CANBERRA DEFENCE PRECINCT TRANCHE 1 AUSTRALIAN DEFENCE FORCE ACADEMY LIVING-IN ACCOMMODATION PROJECT

SUPPLEMENTARY SUBMISSION

**STATEMENT OF EVIDENCE
TO THE
PARLIAMENTARY STANDING COMMITTEE
ON PUBLIC WORKS**

Figure 1

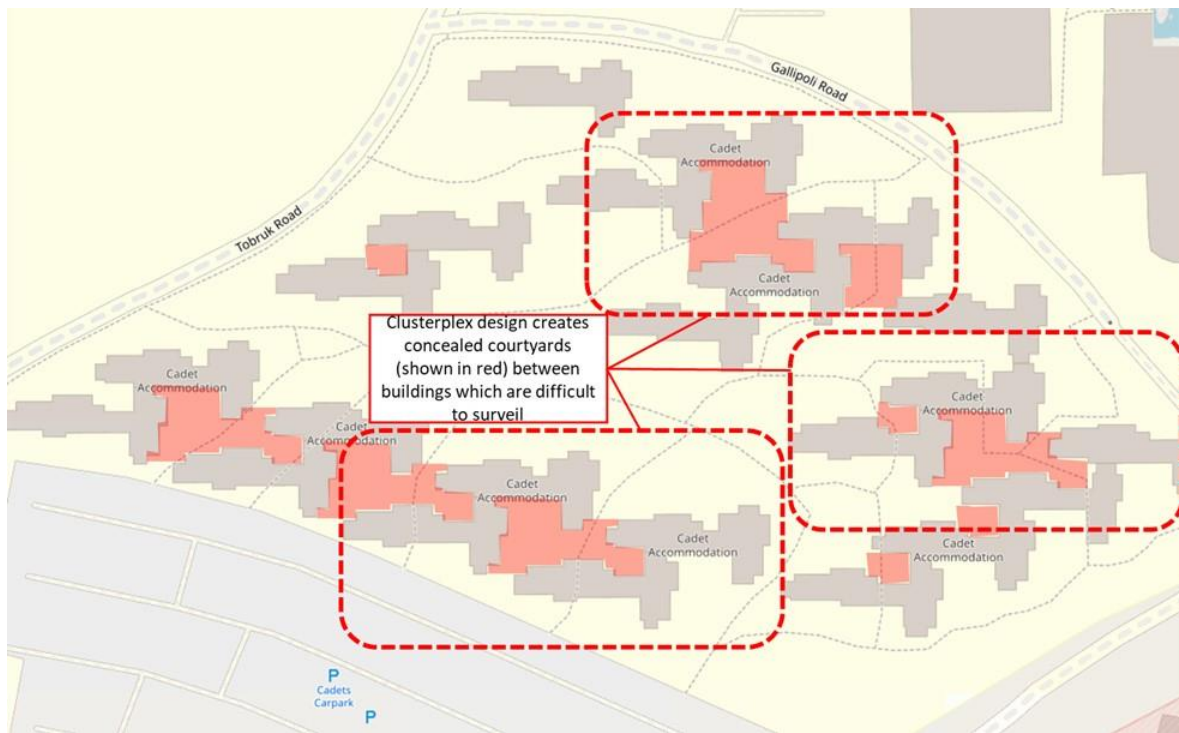
Please provide an explanation of how the current ‘cluster-plex’ design encourages unacceptable behaviour; what is meant by ‘psychosocial risks’ and how will the new design mitigate that risk? It would also be useful to have a short explanation of non-construction initiatives in place to prevent unacceptable behaviour at the facilities.

4. The existing ADFA LIA comprises 23 accommodation buildings arranged in groups of 2-4 buildings, to create clusters, with each cluster consisting of semi-private courtyards at grade. The buildings are constructed on a sloping site, which further exaggerates the semi-private grouping or ‘cluster-plex’ formation of the buildings. A graphic showing the semi-private courtyards is provided at [Figure 1](#). The red dotted lines show groups of buildings that create a cluster, with the red shading showing the external courtyards.

7. The ‘cluster-plex’ design does not encourage unacceptable behaviour. Rather it has been identified as being a contributing or causal factor. Specifically, the following features of the current LIA buildings prevent appropriate mitigation of unacceptable behaviour:
